Detailed Site Plan
Departure from Parking and Loading Spaces
College Park Marriott

DSP-18047
DPLS-485

STAFF REPORT

SUBJECT: Detailed Site Plan DSP-18047
Departure from Parking and Loading Spaces DPLS-485
College Park Marriott

RESIDENCE INN
COLLEGE PARK, MD
BUILDING ELEVATIONS

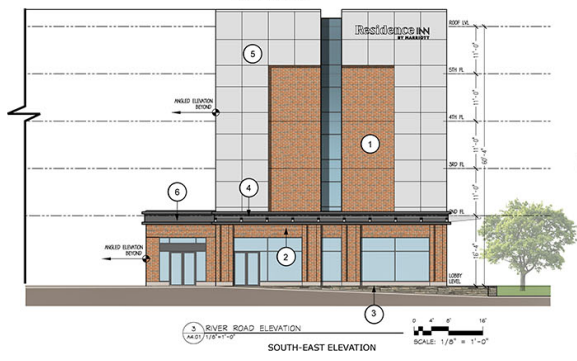
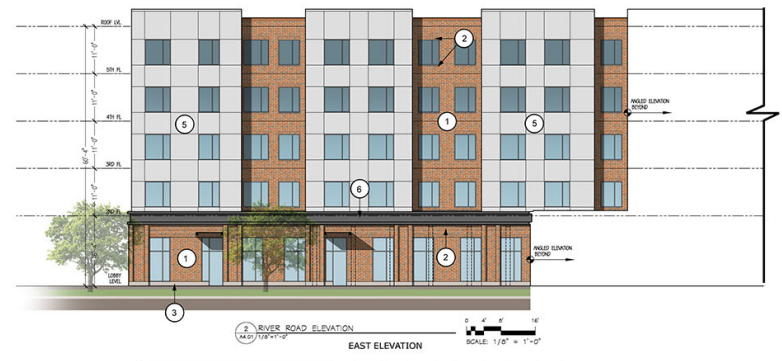
- q. Provide additional windows or architectural articulation on the ground-floor wall of the elevation facing Lehigh Road, in order to enhance visual interest and to activate the street, to be reviewed and approved by the Urban Design Section as the designee of the Prince George's County Planning Board.
